VALIDATION ASSESSMENT

For the name of the 2690 Heater / Cooler PCB FCT Fixture (TE0084014)

Waters THE SCIENCE OF WHAT'S POSSIBLE.™	Validation Assessment Form
Document #: TE0084014-25FEB19-VAF	SAP #: TE0084014QX

Justification: Test Pump Fan Tach ON – Specification Change

Test Ext Fan Control

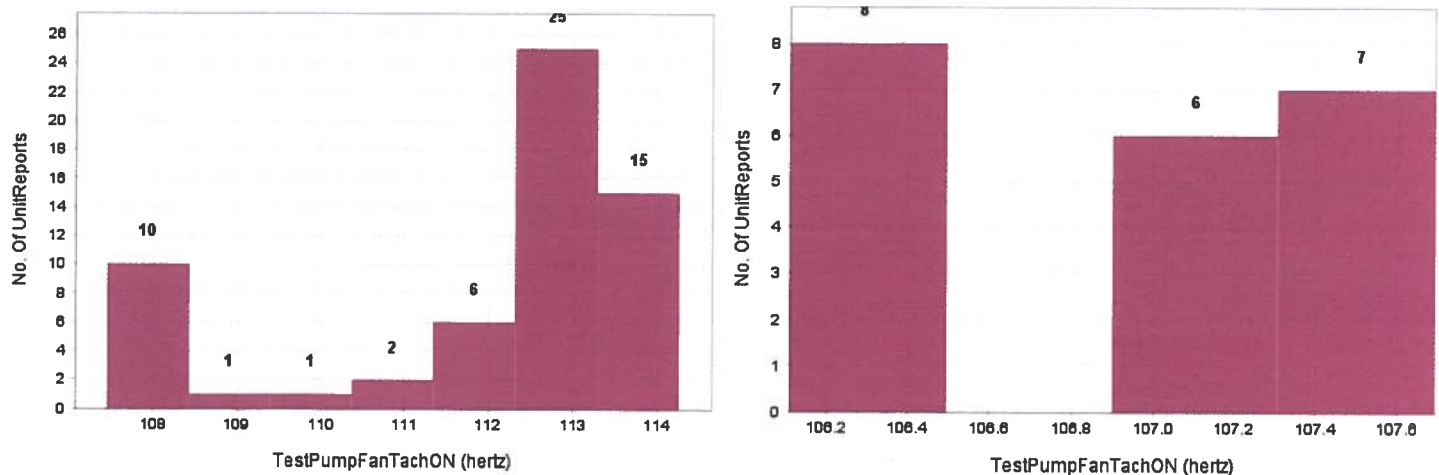
After the transfer of the TE0084014 test fixture, a set of “known good boards,” previously verified using an old manufacturing test, were tested on the new fixture. The old manufacturing test uses a different test method by checking for a pump fan tach error and not the frequency of the signal. The new test verifies the frequency of the pump fan tach signal. It was found that the Pump Fan Tach ON test was consistently failing for one of the UUTs at just below the LSL of 107 Hz (see screenshot of test record below).

This failure was not seen during the development phase or during the equipment design verification (EDV). During that time, all test measurements fell between the specification range of 107 Hz – 115.5 Hz (see distribution below on the left). However, once the fixture was transferred to Flextronics in Malaysia, it was found that all of the known good boards test measurements were falling on the lower end of the specification range (see distribution below on the right), with the board under question falling outside the range.

This indicated that the specification range may be too tight. The performance specifications for the UUT (810000444 and 810000150) were reviewed and it was determined that the specification should be **100 Hz – 128 Hz** based on the tolerances specified (see next page).

The below screenshots from the performance specification indicate that the Pump Fan Tach Signal is the FAN_CLK signal divided down to 114 Hz. The tolerance on the FAN_CLK signal is 12% at 903 Hz. To calculate the proposed specification, the lower and upper FAN_CLK frequencies were calculated and then divided by the same divisor used to obtain the target 114 Hz.

This results in a specification range of 100.32 Hz – 127.68 Hz. This signal is used to tell the Pump Driver board in the Alliance system that there is not an external fan failure. The detection limit for the board is approximately greater than 50 Hz (as highlighted below); therefore, testing to the specification range of 100 Hz – 128 Hz ensure the signal is higher than the fan failure detection limit in the final instrument.

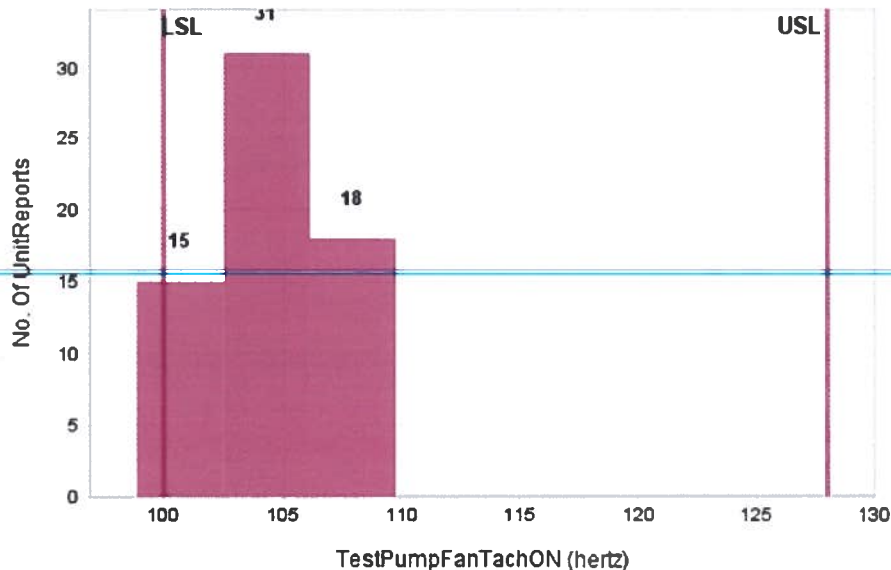
After performing the verification steps outlined in the validation assessment form, it was found that the specification limits still remained too tight. The verification run involved testing 50 boards to the specification of 100 – 128 Hz, which resulted in 4 failing just below the 100 Hz LSL. See a screenshot of the histogram of the results below:

As stated in the performance specification for the 210000444 PCB, **as long as the pump frequency is greater than the detection threshold of 50 Hz**, the unit will see this as a properly operating fan. See the screenshot below of the performance specification. The LSL for this test should be 50 Hz.
